| BOD    | 2026MY<br>EV9 (MV1a) |
| 355    | June 2026            |

## TECHNICAL SERVICE BULLETIN

### FRONT SEAT SLIDE MOTOR NOISE (CA2603)

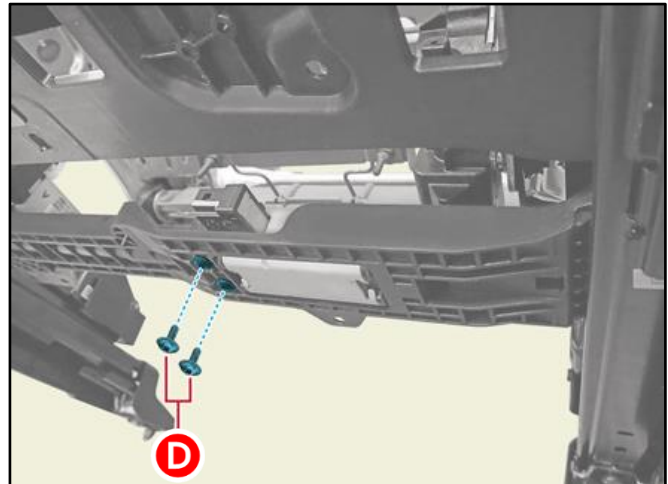
- 1a. Open the rear seat bolt caps (A) of the driver seat.
- 1b. Loosen the two (2) rear seat bolts (B).

Tightening torque for bolts (B):  
32.5 - 43.4 lb.ft (44.1 - 58.8 N.m)

2. Place a piece of wood under each seat rail (C) to lift the rear end of the driver's seat.

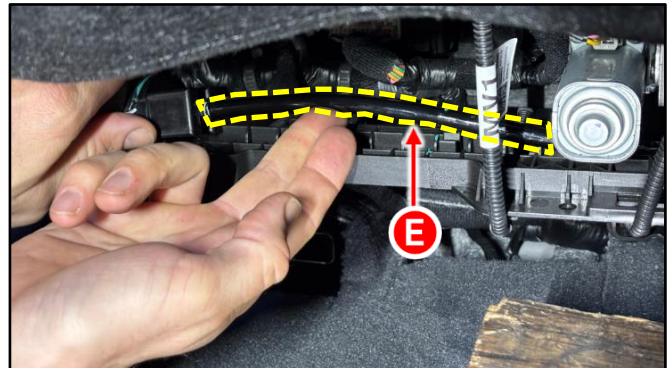
4. Loosen the two (2) screws (D) to remove the sliding motor.

- 5a. Lift the sliding motor cable (E).

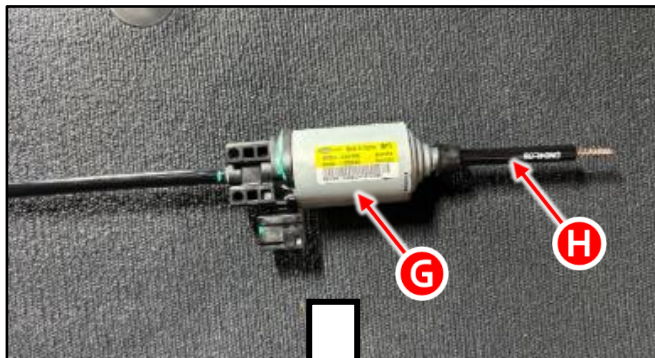
5b. Disconnect the sliding motor connector (F).

5c. Remove the sliding motor (G).

6a. Remove the sliding motor tube (H) off the sliding motor (G) and discard.

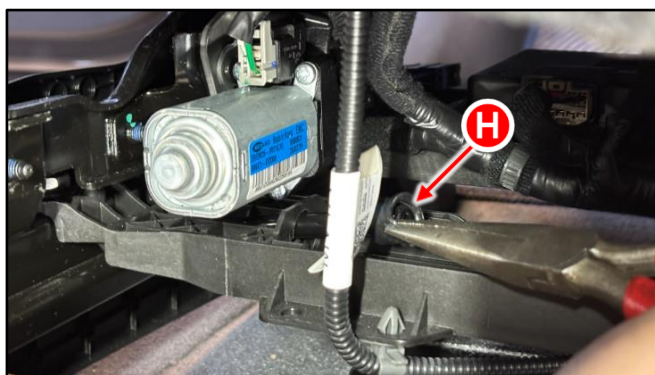
6b. If the sliding motor tube (H) does not come out with the sliding motor, use needle-nose pliers to remove the sliding motor tube (H).
